# ***Interactive comment on “Estimating reflectivity values from wind turbines for analyzing the potential impact on weather radar services” by I. Angulo et al.***

**I. Angulo et al.**

Received and published: 26 March 2015

Fig. 1.

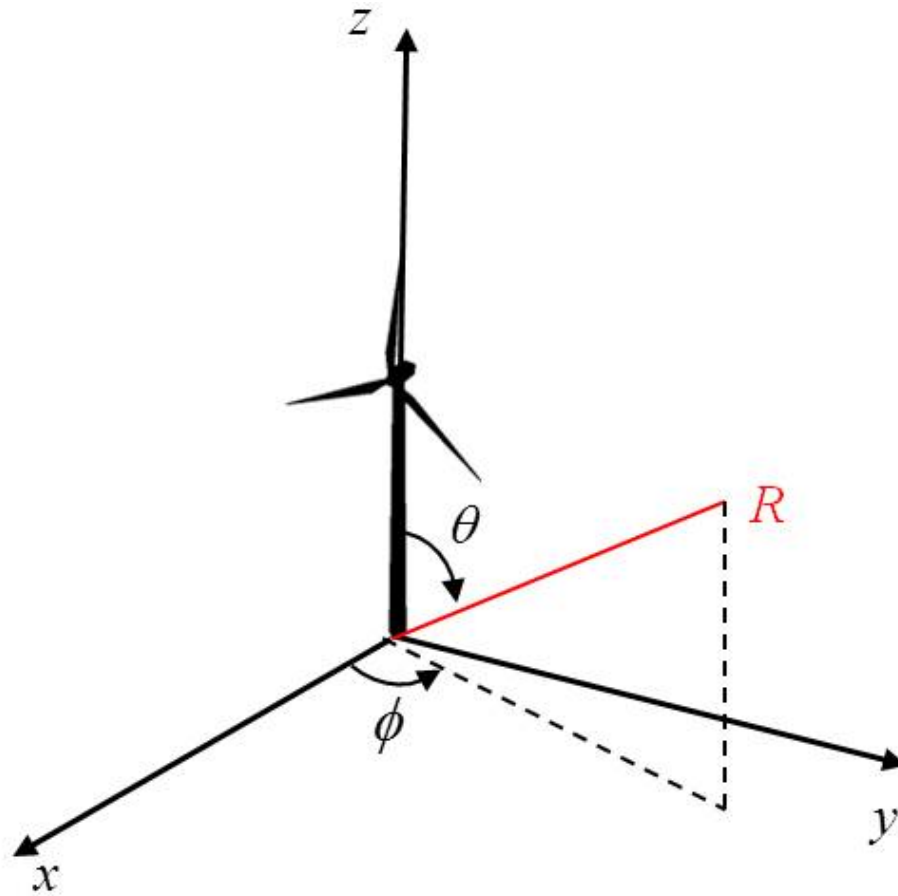
2. Page 1484, Line 23-24 It is not apparent to the reader what the theta and phi parameters represent exactly. It should be clear in Figure 1 what phi represents, and that it is referenced to the normal of the blade face and toward the radar along the radar line of sight (I think?). It would also be useful to define a parameter for the blade

rotation plane, again with explicit descriptions so the reader can visualize easily.

In order to make the coordinate system clearer, Fig. 1 has been simplified. Moreover, theta and phi parameters have been explained in Section 3.1.1, “Simulation tool and wind turbine models”, which was Section 3.2.1 before but has been moved to the beginning of Section 3 in order to clarify the coordinate system before explaining the considerations of the analysis (now in Section 3.2). The last paragraph of Section 3.1.1 is now as follows: “Fig. 1 shows the reference coordinate system for the analysis. The wind turbine rotor is supposed to be oriented towards the x-axis and R refers to the radar position. As shown in the figure,  $\theta$  is the angle from the zenith that defines the radar position in the vertical plane, and  $\Delta d'$  specifies the horizontal position of the radar with respect to the rotor orientation, i.e., with respect to the rotor shaft axis ”
